Beaver Valley Power Station, Unit No. 2  
Proposed Technical Specification Change No. 87

### Beaver Valley Power Station, Unit No. 2 Proposed Technical Specification Change No. 87 REVISION OF SURVEILLANCE REQUIREMENT 4.6.2.2.d

#### A. DESCRIPTION OF AMENDMENT REQUEST

# RSS Test Configuration

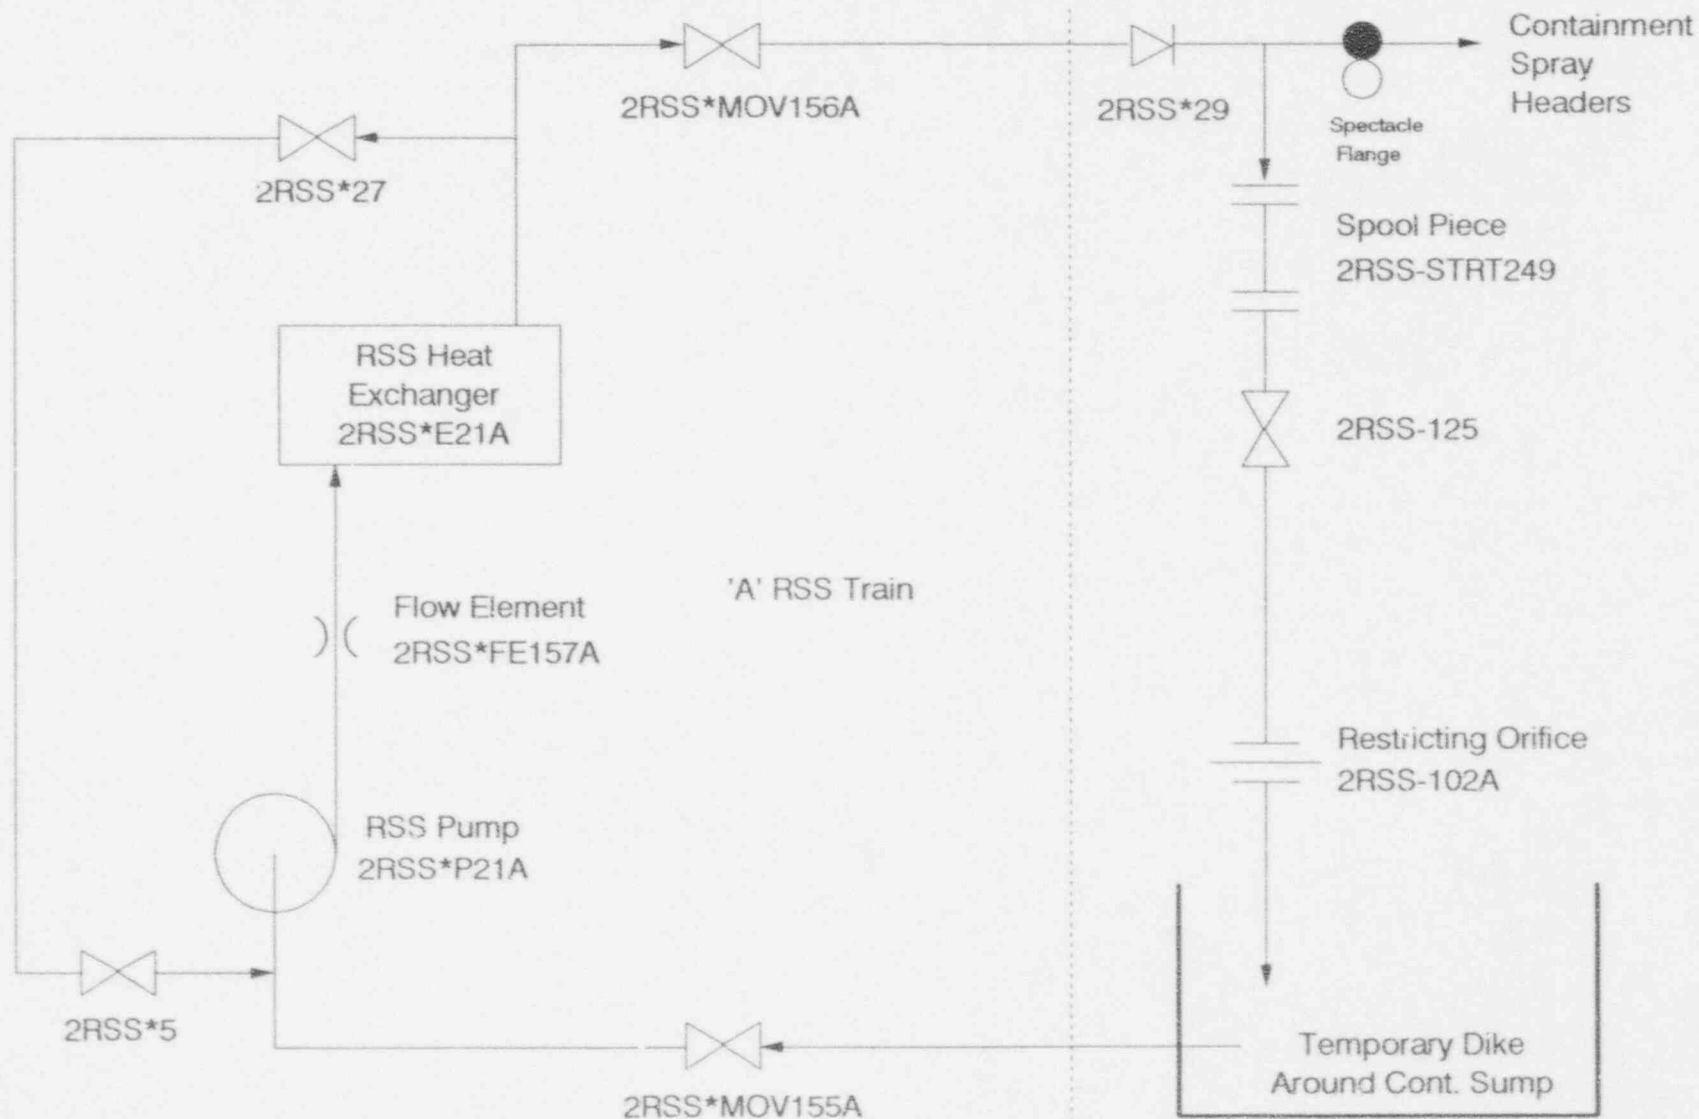
The flow path used to test 2RSS\*P21A can be seen on Figure 1 (Page B-13) and is described as follows: The RSS pump 2RSS\*P21A (located outside containment) takes suction from the temporary dike (located inside containment) through the suction MOV [2RSS\*MOV155A] then discharges flow through flow element [2RSS\*FE157A], heat exchanger [2RSS\*E21A], discharge MOV [2RSS\*MOV156A], discharge check valve [2RSS\*29], spoolpiece housing [2RSS-STRT249], throttle valve [2RSS-125], and finally through restricting orifice [2RSS-102A] back to the temporary dike around the containment sump. The restricting orifice provides a flow of approximately 3500 gpm (the current minimum technical specification required flow). In order to meet or exceed the minimum technical specification required flow, an additional mini-recirculation flow path is valved in to provide a total throttled reference flow between 3500-3550 gpm as required by the ASME XI Inservice Test (IST) Program. This flow path is provided through valves [2RSS\*27 and 5] from the pump discharge back to the suction of the 2RSS\*P21A pump.
